Case No. P/425 of 1932.

Applicant's Name A. Kharali A. HalaiArchitect's Name B. H. WadhwaPlot No 166 Sheet No. M. R. 1, Market Quarter

KMR.CDD.MIQ.1932-1933.01 G

PROPOSED 1ST 2ND 3RD FLOORS TO BUILDING
ON PLOT N^o 166 M.R. 1 MARKET Q^R.
SCALE 8-1

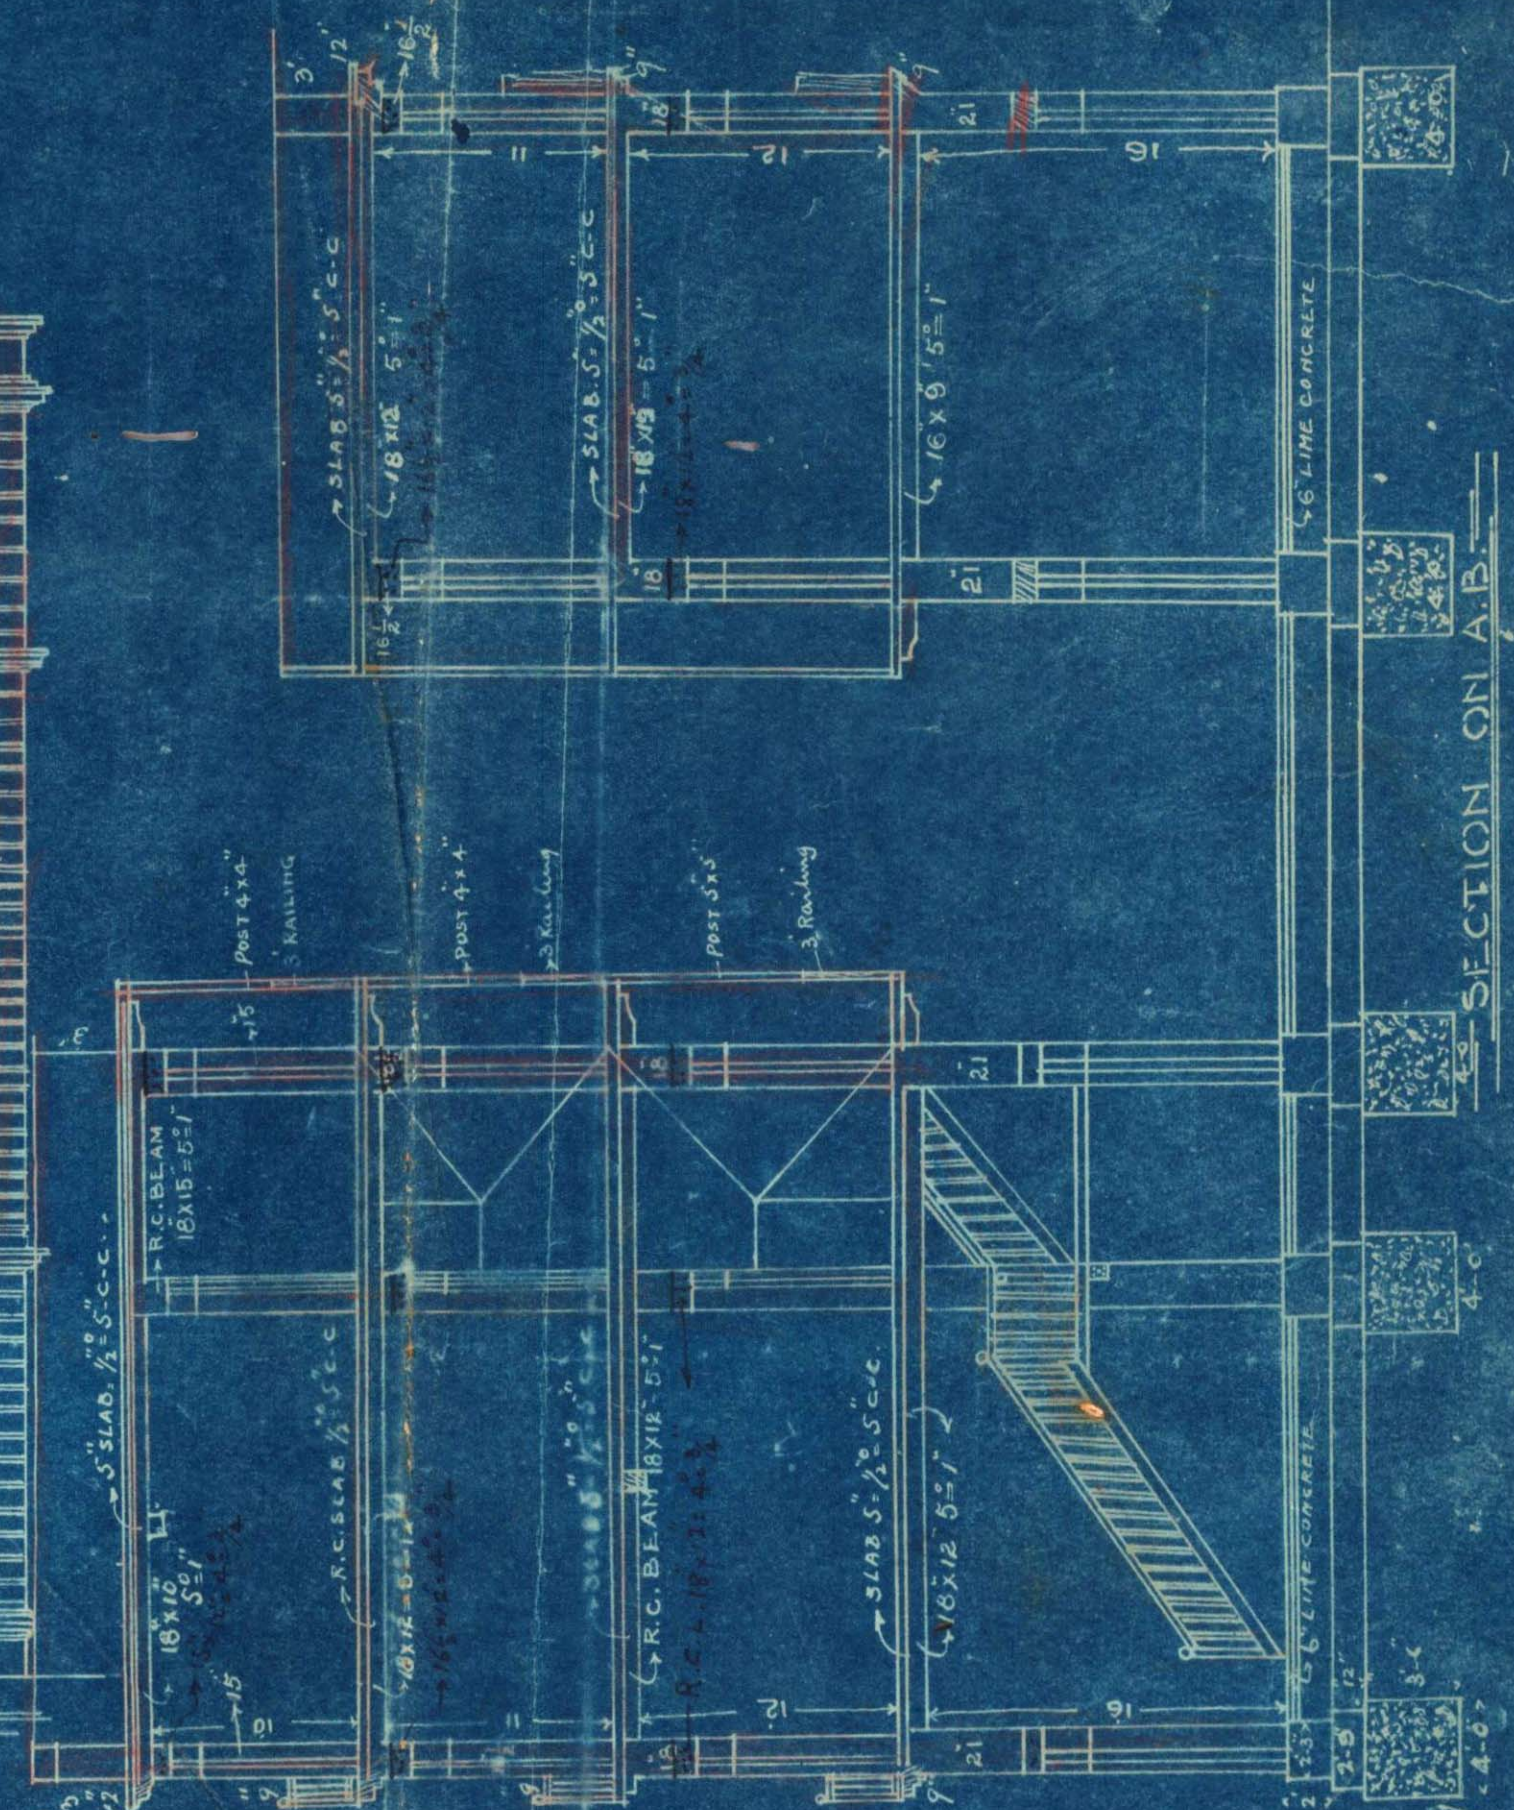
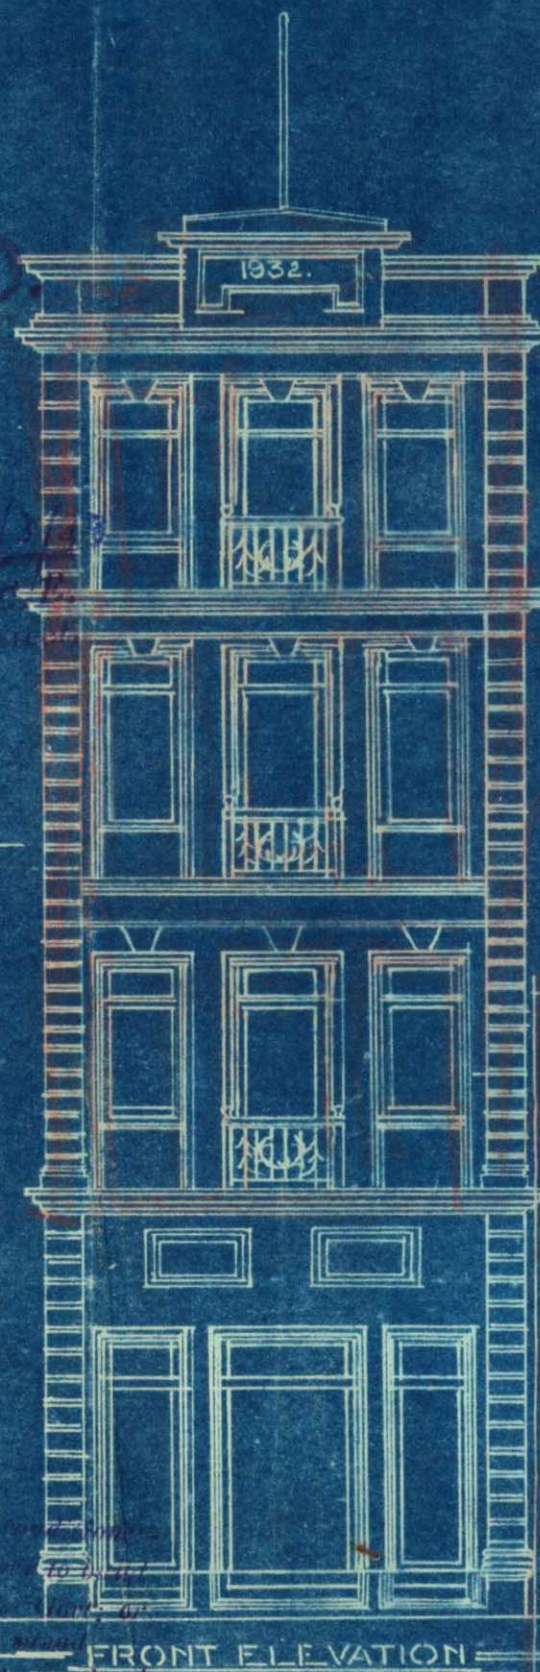
With reference to your letter dated 31st October 1932 re-above, I have to inform you that in the plan passed in 1923, the whole building was surrounded by masonry pucca walls. In the building as actually put up, he has practically very little of pucca walls.

If he wants upper floors, he must design the whole building newly trying to make use of the old ~~xxxxxx~~ materials. Fresh foundations will have to be dug wherever necessary.

*Please call the architect
for mark corrections as
shown in note in the plan*

ments of this office will be pointed out to you. The plans be submitted after making necessary corrections shown in the accompanying plan

- (1) The existing building is not strong enough to carry the upper floors.
- (2) The existing ground floor has walls with too many openings and no return walls at all.
- (3) The masonry of the main wall is Rubble masonry and is therefore the proposed upper floors cannot be allowed.
- (3) External walls must be made of brick.

With reference to your letter No. B.S.P. 425/32 of 23rd inst. I beg to submit herewith the attached copies of plans duly corrected as desired by you. One copy of plan is also mounted on cloth. I request the favour of your early sanction on the same and oblige.

*Submitted to M.A. with the
report that the architect has removed
all the objections the plans may
be approved.*
